# Hydro 2000 Inc. Response to OEB Staff Questions

## EB-2022-0038

Ref 1: IRM Rate Generator Tab 11 – Retail Service Transmission Rates (RTSRs)

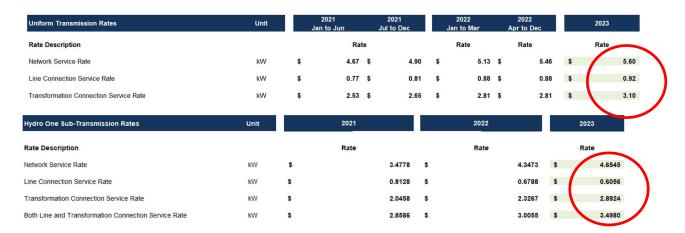
OEB staff made the following updates to Tab 11 of the rate generator model:

a) Please confirm the accuracy of the updates.

H2000 Responses: H2000 confirms that the updates are up to date and accurate.
